# REPLACEMENT SYSTEM VARIANCE REQUEST

Permit No. 3472  
~~3742~~ E

Town of Augusta

# SUBSURFACE WASTEWATER DISPOSAL SYSTEM APPLICATION

## SITE PLAN

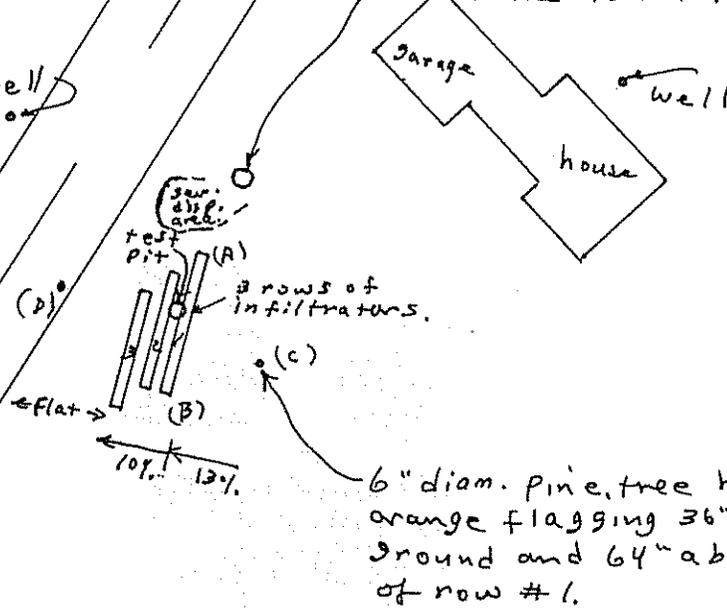
1. Fill extension Grade—to 3:1 on lower side only.
2. \* NOTE: the sewage disposal system proposed is as far or farther from the neighbors well as the old system. The well is newer than the existing sewage disposal system
3. Footnotes:

Pump old tank & remove or fill with dirt. Place new tank in same area, at least as far from neighbors well as the old tank.
